MEMO

To: Kristopher Byrd, Well Construction and Compliance Section Manager
From: Travis Kelly, Well Construction Program Coordinator
Subject: Review of Water Right Application G-19067
Date: August 18, 2021

Groundwater Application Review Summary Form

Application # G- 19067

Well Location Map

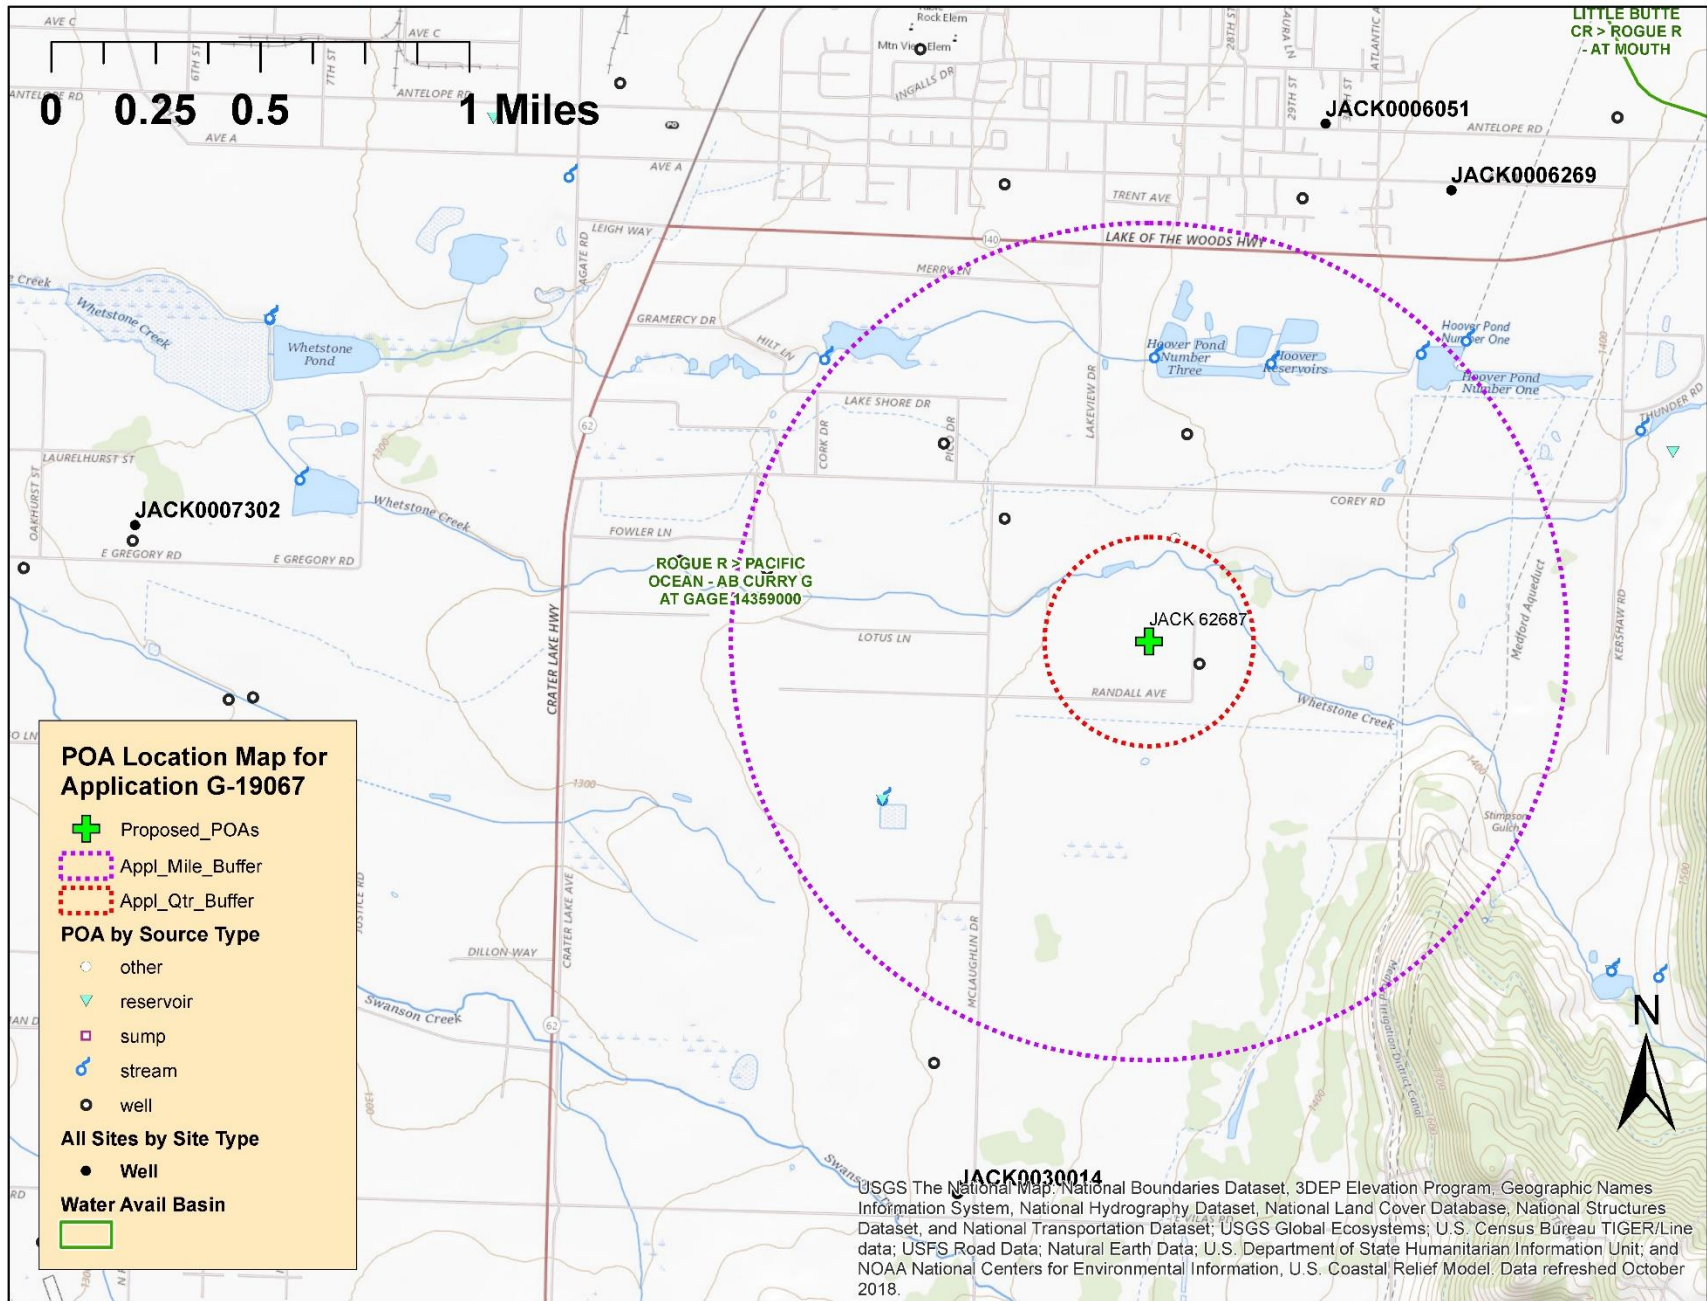
B3. **Groundwater availability remarks:** The applicant’s well accesses an aquifer hosted in secondary fractures and joints of the Payne Cliffs Formation. Wells in the vicinity have low-moderate yields (median yield = 22 gpm) and are shallow (>50 % are less than 100-feet deep). Well reports and water level records from JACK 7302 from 1960 to 1986 indicate that water levels are typically between 5-20 feet BLS. There is insufficient water level data to determined whether the resource is over-appropriated at this time.

There are several adjacent tax lots that are likely supplied by exempt use water use wells and JACK 6382 under certificate 57119, which will likely be impacted by the requested use. Considering the relatively low requested rate/volume and the distance between the applicant’s well and the adjacent developed properties, resulting well-to-well interference is not likely to prevent adjacent well owners from accessing their customary amount of water.
